West

Sydney International Speedway Submissions Report

November 2020

Figure 7-1: Sydney International Speedway onsite detention catchment plan

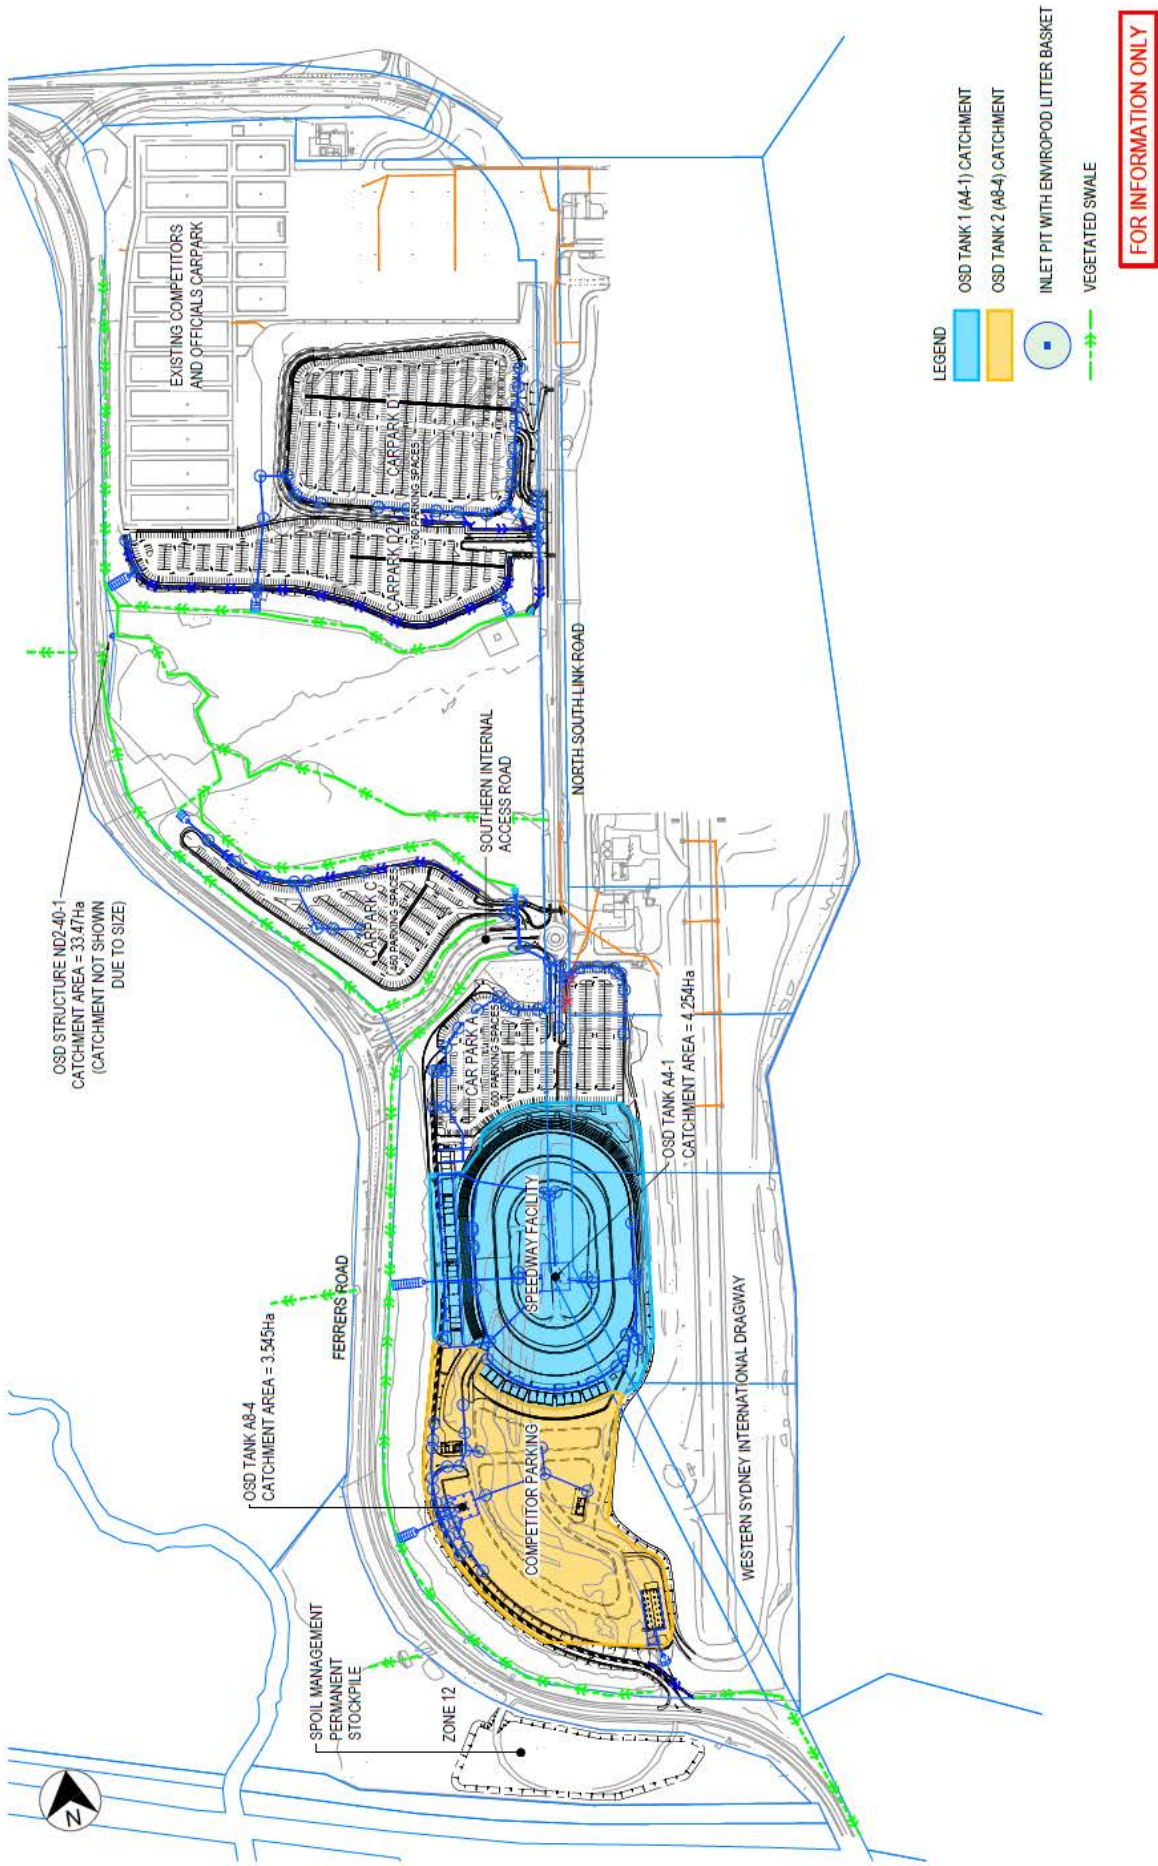
The proposed amendment would remove the proposed on-site detention tanks associated with Carparks A, C and D. The water quality measures for these car parks would be developed during detailed design taking into consideration the criteria taken from *Part J: Water Sensitive Urban Design and Integrated Water Cycle Management of the Blacktown Development Control Plan 2015*. These measures could include one or a combination of vegetated swales, bioretention systems, gross pollutant traps and water quality basins or tanks.

The project includes a 1200 cubic metre (m³) dual purpose rainwater collection tank and detention basin, located at the centre of the speedway race track. The outlet of the on site detention tank is located higher than the base of the tank so that 200,000 litres of stormwater can be retained to provide water for dust suppression and track maintenance before and during events at the Sydney International Speedway. Non-potable water would be used across the site for dust suppression only. Water demand for the remainder of the project site including washdown, amenities, irrigation and taps in car parking areas would be met via mains water supply, in consultation with Sydney Water.
